Further Information Request

Rum Jungle Rehabilitation Project – Environmental Impact Statement

Document title	Further Information Request
Contact details	Department of Industry Tourism and Trade
Author	A. Wilkins
Date Issued	23/08/2021

Figure 1: Project Governance Model

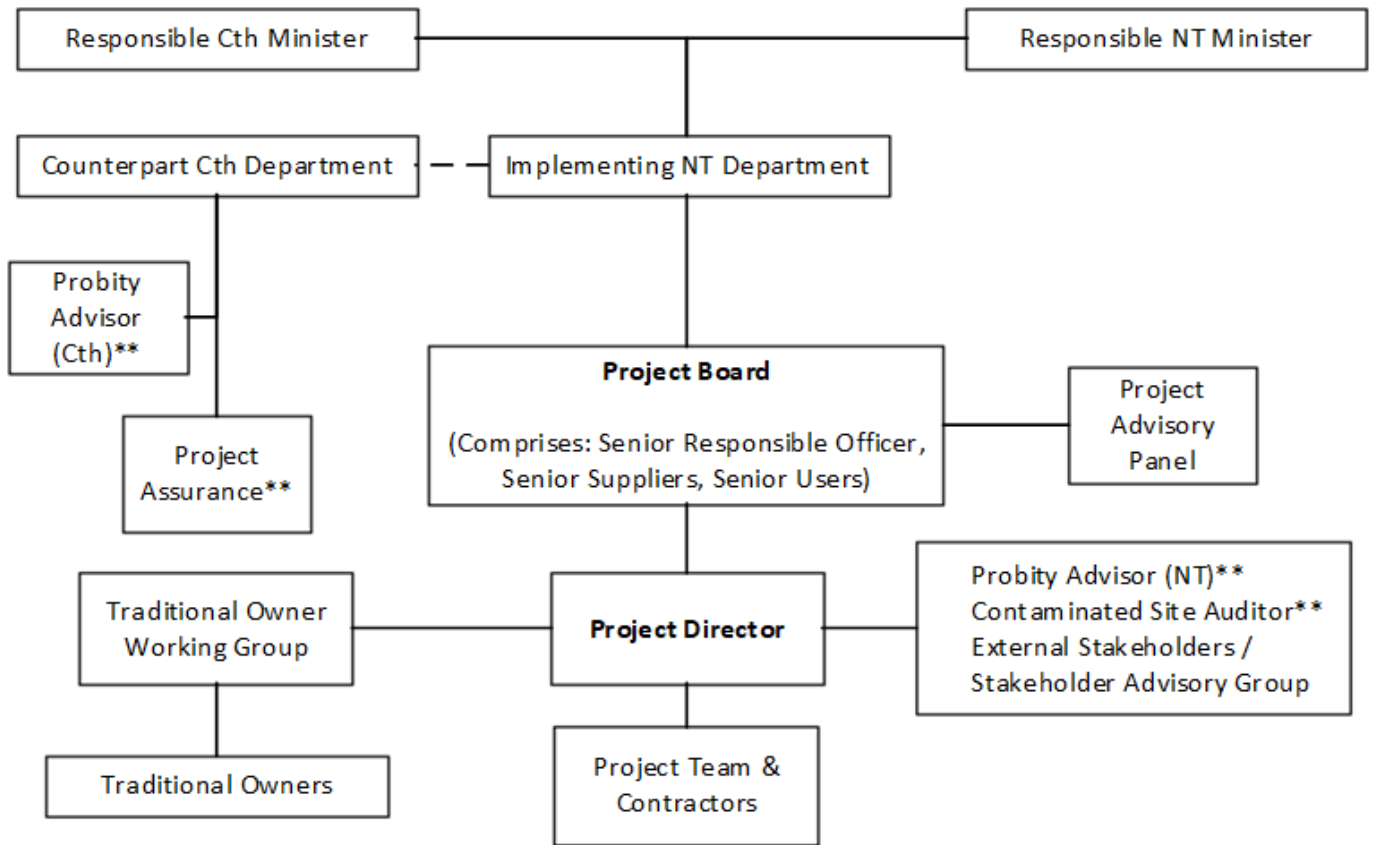
Comment	Governance, reporting, engineering oversight and auditing plays a significant part in the ongoing and long-term management and success of the proposed activities including proposed mitigation and management commitments. The Supplement and Appendix 1 indicate that further information about this is available.
Further Information Required	<p>Provide further information about the ongoing and long-term management of this Proposal, including:</p> <ul style="list-style-type: none"> • the Governance Board (e.g. participants, purpose, role and responsibilities, for how long it will exist etc.) • an outline of audits and technical reviews planned (short and long-term > 20yrs) • identifying who will take responsibility for actioning and achieving outcomes of rehabilitation management plans • approach to management/provisions after Stage 4 (> 20 years) to ensure the required land management of the cover systems is maintained • reporting structures, including communication to stakeholders and the public. <p>The information should be supported with diagrams where possible.</p>

experienced in similar major capital works projects. The proposed structure of Stage 3 Project Governance is included at Figure 1: Project Governance Model.

The Traditional Owner working group, Project Advisory Panel and other technical experts are yet to be formed and formalised however this Governance Model is the target framework to be established to support Project delivery.

Figure 2: Distribution of PAF materials by current Waste Storage Location

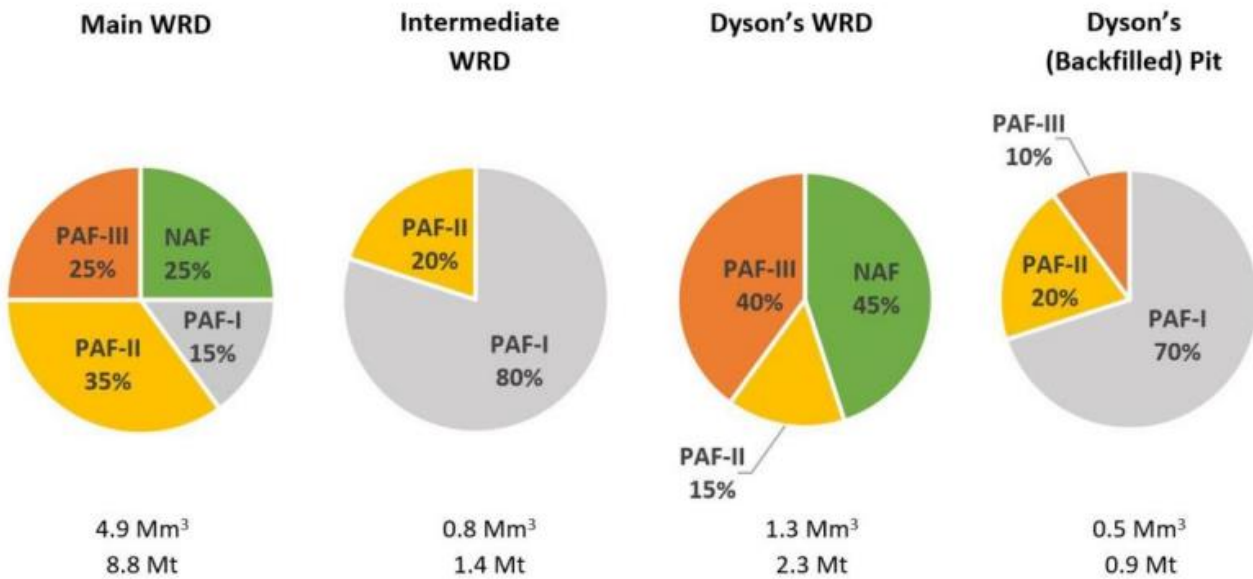
Comment	The Supplement indicated that materials would no longer be segregated at the deconstruction loading face.
Further Information Request	Clarify if PAF-I material would still be deposited in the Main Pit. If yes, provide information about a field validated segregation method, and associated quality assurance/quality control program for waste rock identification, segregation and management. If no, would less waste rock be deposited in the Main Pit?

Material used in the Main Pit backfill process will primarily be composed of PAF-I waste rock, the majority of which will be the 0.8Mm³ of waste rock stored within the Intermediate WRD. Additional material from Dyson's Backfilled pit and the Main WRD will also be placed within the Main Pit to meet the design elevation specifications as outlined within the SLR 2020p Main Pit Design Drawings (Appendix 25 of the Supplementary report). Materials will not be segregated at the deconstruction face as the Project has an adequate understanding of the volumes and percentage of PAF material stored in the existing facilities as indicated by Figure 2 below.

Figure 3: Zones 3 and 4 Potential Sensitive Receptors.

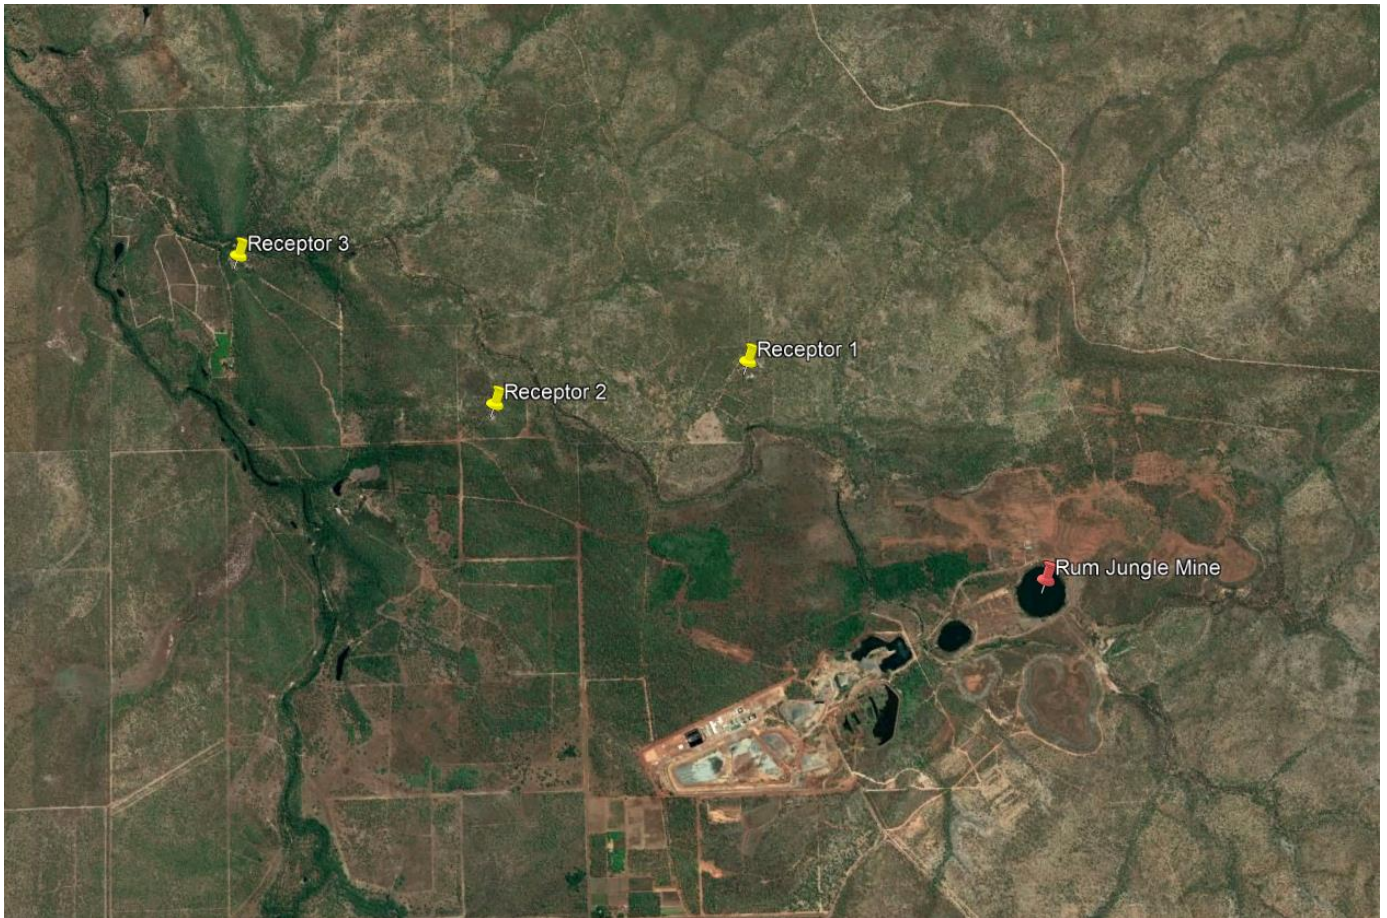
<p>Comment</p>	<p>The Supplement refers to Hydrobiology reports. Appendix 3 (Hydrobiology 2013a) outlines the downstream environmental values by zone. Zones 5 and above include recreational use, drinking water, irrigation, stock water and farm supply. Zones 3 and 4 are of most concern as they are immediately downstream of Rum Jungle proper and do not include the full range of human use values (table 6-1).</p> <p>Viewing of satellite imagery (NR Maps / Google Maps) indicates that there are some buildings/houses in zones 3 and 4 and access tracks to the River (EBFR). It is unclear whether/how residents may use the river or water from it.</p> <p>As the water in these zones of the EBFR is not, and will not be, suitable for many human uses, it is important for the Proponent to communicate with the owners, and anyone who has access to, all properties in zones 3 and 4, regarding appropriate use of the EBFR and its water.</p>

<p>Further Information Request</p>	<p>Provide a summary of any consultation undertaken with owners/occupants of the properties with access to the EBFR in zone 3 and 4 in relation to their usage of the EBFR.</p> <p>Provide a commitment that appropriate communication and engagement with all owners, occupants and visitors to the properties in zones 3 and 4 of the EBFR will be addressed in the Stakeholder Communication and Engagement Strategy (commitment 41).</p>

There are three downstream dwellings with access to EBFR within Zones 3 and 4. These are shown as Receptors 1, 2 and 3 in Figure 3.

Additional access to Zones 3 and 4 are through Finniss River ALT and NT Crown Land portions with no occupation. The project is committed to the development and implementation of a Stakeholder
